SUBSURFACE WASTEWATER DISPOSAL SYSTEM APPLICATION

Street Subdivision Lot #: TASKER ROAD

AUGUSTA PERMIT # 487 TOWN COPY

Replacement System Variance Request

SUBSURFACE WASTEWATER DISPOSAL PLAN

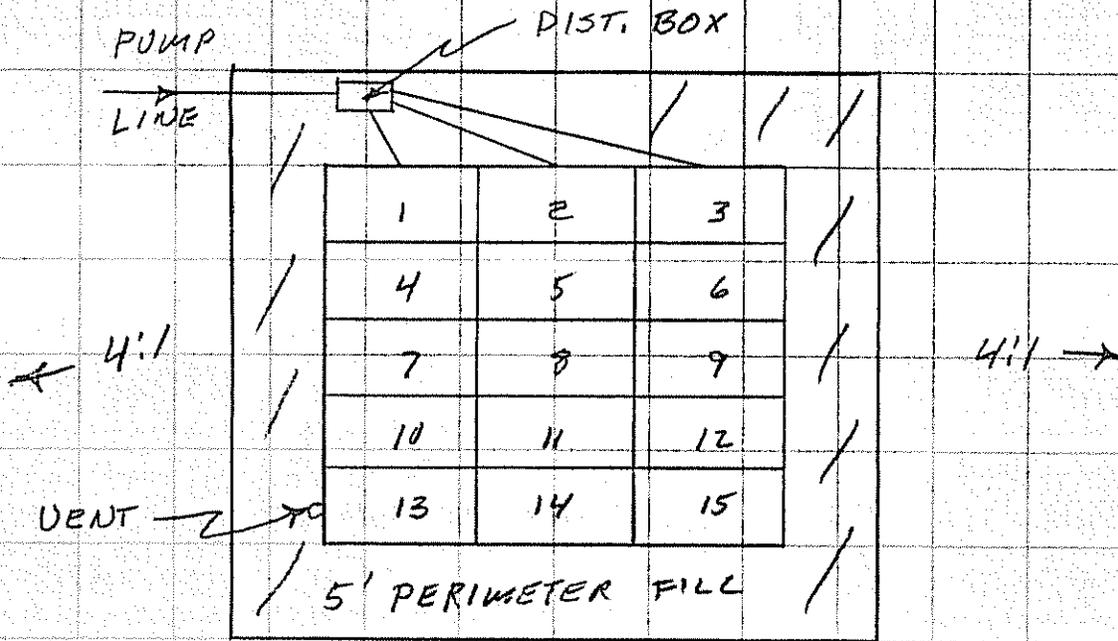
Comments: *System too close to homeowner well as well as neighbor's well. My Authority 66' For Homeowner 80' from neighbor's well*
